U.S. Patent Application Serial No. 09/923,914  
Reply to Office Action of **October 17, 2003**

**REMARKS**

FIG.3

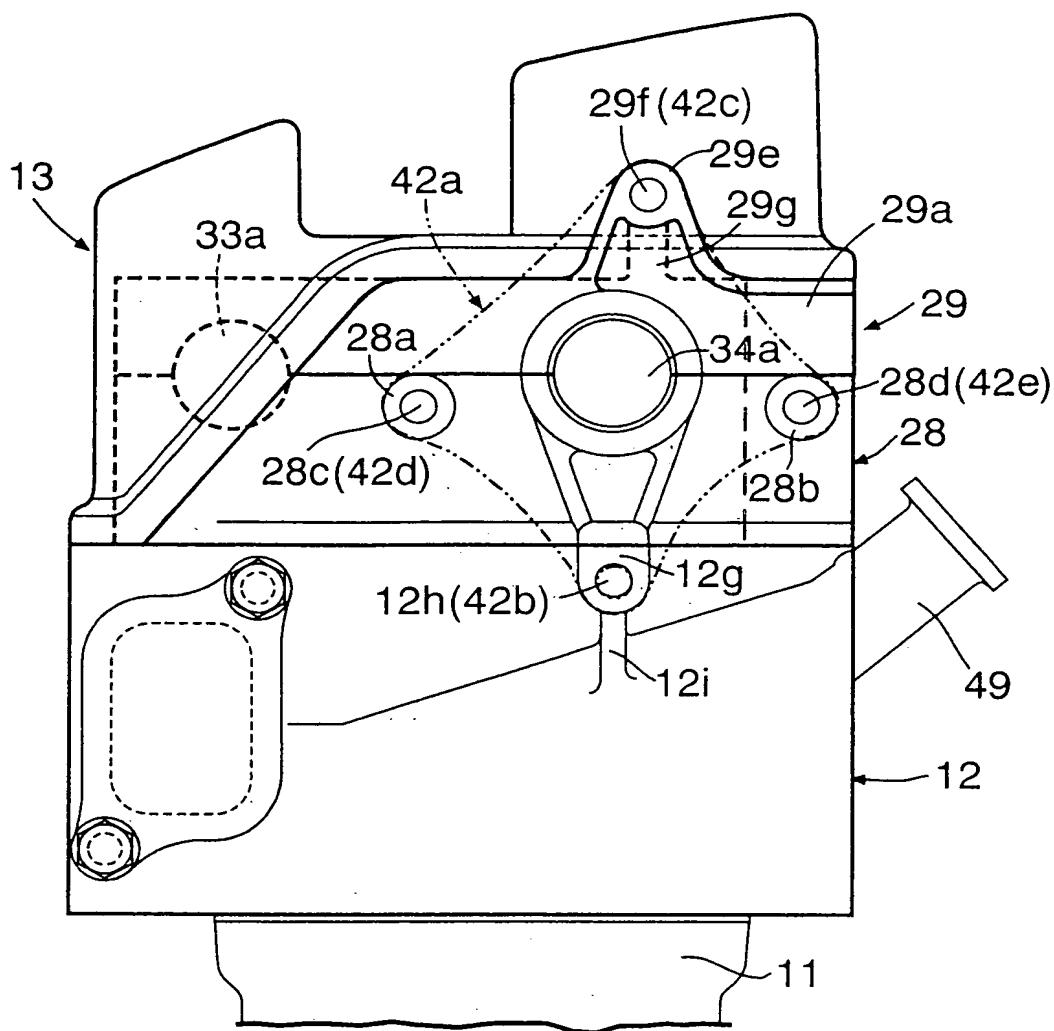
Also, Figs. 1, 2 and 3 of the drawings are hereby amended in order to correct minor defects therein; namely, the removal of arrow 2 from Fig. 1; in Fig. 2 the addition of a vertical dotted line and the change of a dotted line portion to a solid line; and in Fig 3, the addition of a dotted line similar to that in Fig. 2; and embolding of the oblique line, all as shown in red on the enclosed drawing copies.
